CASE #21-DDP-0116
WM #12382 / 21 1206

SUNSHINE CONCRETE
OWNER
OTTE FAMILY LTD PARTNERSHIP
12902 SHELBYVILLE RD
LOUISVILLE, KY 40243

SITE LAYOUT PLAN

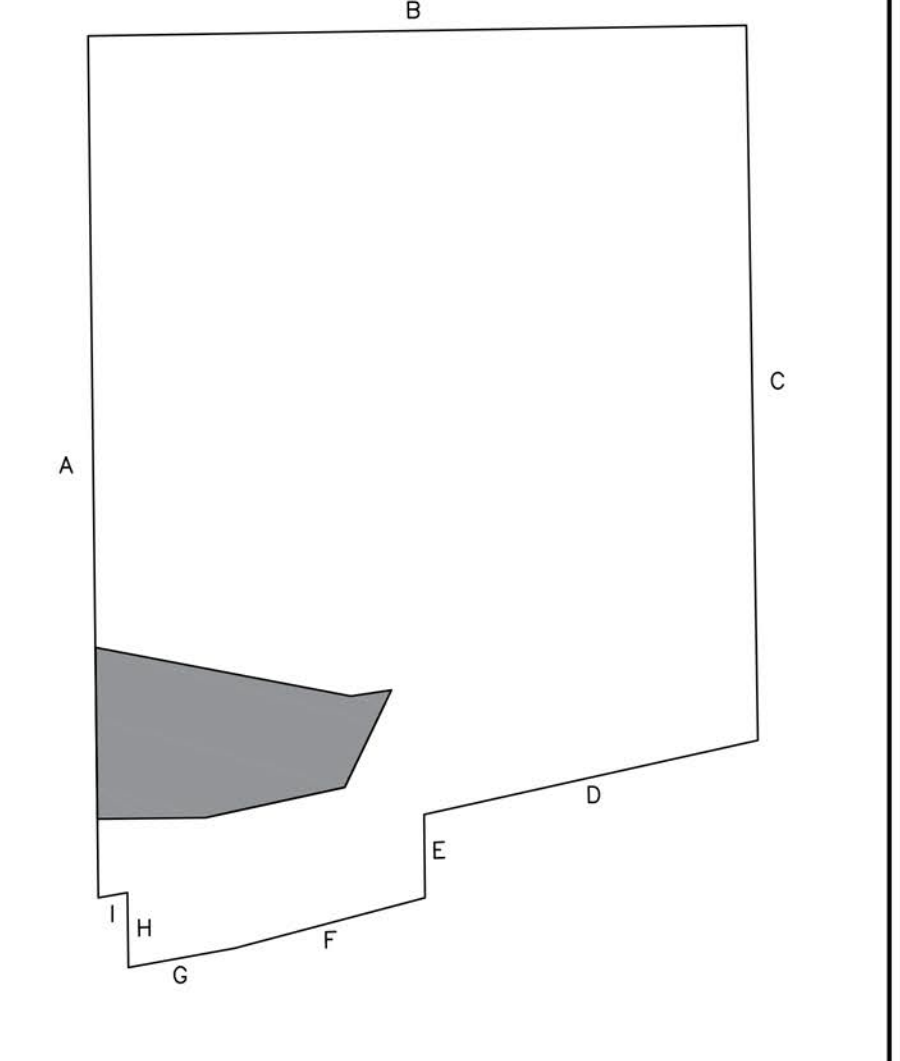
Overall, there is a complete lack of dimensions shown on this plan. There are no dimensions shown for buildings, fuel station, aggregate storage bins, or truck wash out from any property lines. The DDP application requires Building Setbacks with Dimensions as well as typical dimensions of parking spaces and aisles.

There are no renderings showing the views from all sides of the buildings, nor any elevations showing the silos and actual concrete mixing plant.

The berm proposed on the east of entry drive is not wide enough as shown to even be 6' height assuming a 3:1 max slope.

The entry drive has no indication that it will be a solid paved roadway. It shows a 24' dimension but no callout to paving type other than the screened back survey below that shows gravel on both sides of the narrow concrete strip. If this road remains gravel it will be a major source of dust contribution.

How tall are these storage areas. They should likely require elevations to be submitted as well.

No renderings or elevations were submitted for the actual concrete plant structures and silos. These are major structures on the site and should require elevations as well. The District Development Plan application requires "One set of renderings of the buildings proposed for the site. The rendering must contain ALL sides of building."

No renderings were submitted with the revised plan to show what this building is. The District Development Plan application requires "One set of renderings of the buildings proposed for the site. The rendering must contain ALL sides of building."

No renderings were submitted with any of the submittals. A picture of a warehouse located at 1103 Spencer Hollow Way was submitted. The District Development Plan application requires "One set of renderings of the buildings proposed for the site. The rendering must contain ALL sides of building."

Berm will need to be planted with mature plantings. A mix of deciduous trees and evergreen trees should be utilized. Trees should be installed with a minimum height of 15'. Trees should be triangulated on the berm to provide a contiguous screen. A row of trees at 30' on center at 1 3/4" caliper size will do nothing to stop dust and/or provide screening. A hardy evergreen hedge should be placed on the top of the berm. This hedge should be able to grow to 10'. This entire area around the concrete silo/plant should be considered vehicular use area as trucks will be driving around this entire area.

Providing a wheel wash system at this location would help to reduce dust and keep contaminants on the subject property. This can be accomplished by a simple 6'-8" wide water filled trough that has a full rotation through upon exiting the yard.

This entire 24' needs to be called out as concrete. There is a 24' dimension at the Aiken entry but it does not specify that the whole road will be concrete.

A 6' ft berm WILL NOT fit in this 28' +/- dimension. Assume max of 3:1 slope.
